Source: T1
Title: CR's to TS 34.121 v3.12.0 for approval
Agenda item: 5.1.3
Document for: Approval

This document contains 7 CRs to TS 34.121 v3.12.0. These CRs have been agreed by T1 and are put forward to TSG T for approval.

Figure 5.4.2.4 Inner Loop Power Control Test Steps

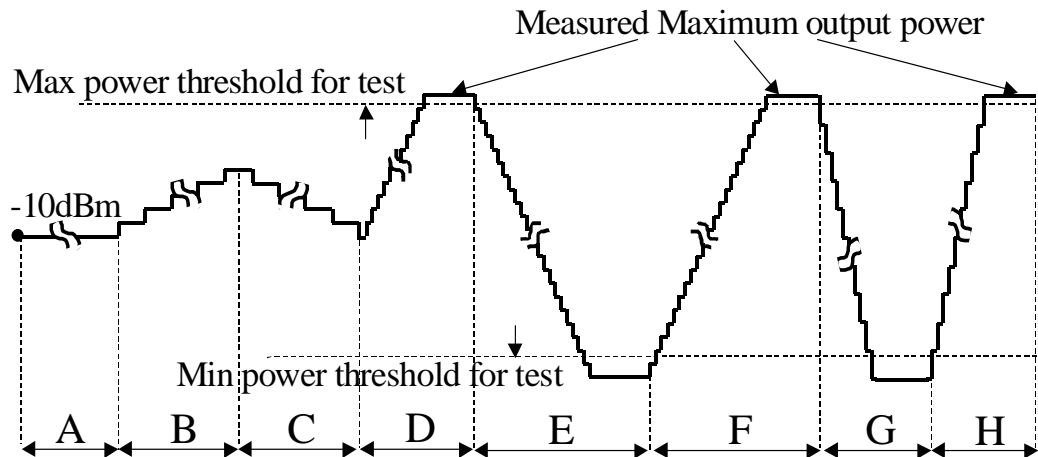
Reason for change:	⌘ Test tolearances were not incorpolated to the test requirement
Summary of change:	⌘ Added a table of the test requirements with test tolerances. Removed the blankets from the correspondng vlues in Tables F.1.2, F2.1, and F.4.1
Consequences if not approved:	⌘ The test requirements have no test tolerances

NOTE 1: These numbers of TPC commands are given as examples. The actual number of TPC commands transmitted in these steps shall be at least 10 more than the number required to ensure that the UE reaches the relevant maximum or minimum power threshold in each step, as shown in figure 5.4.2.4.
